# T3 Volume Driver Appendix

Draft Determination Response

**Scottish & Southern**  
Electricity Networks

# Ofgem's Volume Driver vs Our Proposed Volume Driver

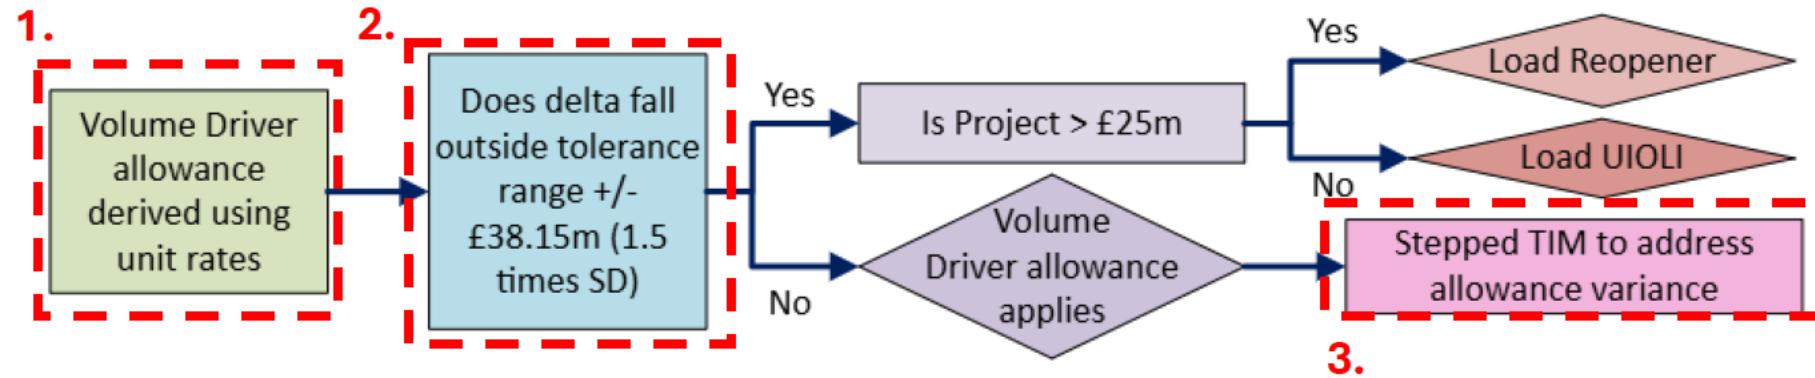
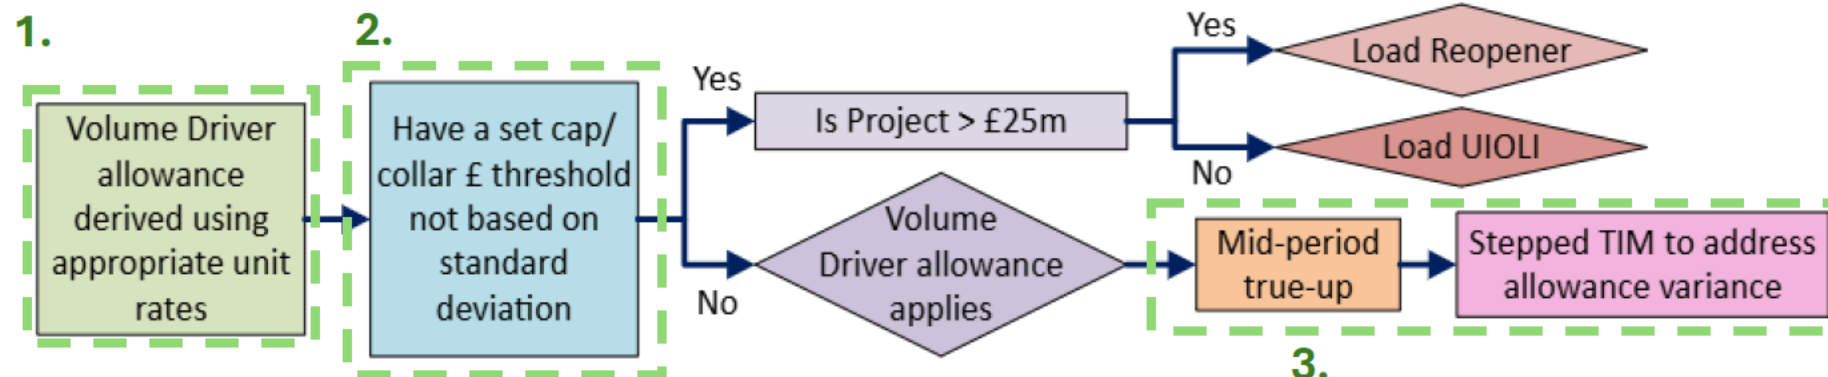
We believe that Ofgem must make changes to the proposed volume driver mechanism. Below is Ofgem's proposed volume driver versus our proposed volume driver

## Ofgem's Proposed Volume Driver

## Our Proposed Volume Driver

Key changes include:

1. **Appropriate Ex Ante Unit Rates** that reflect the projects we are delivering

2. **Atypical Threshold** that does not place too much risk of over/under recovery on a project-by-project basis

3. A volume driver portfolio **mid period true up** to account for material portfolio risk driven by poorly calibrated unit rates.
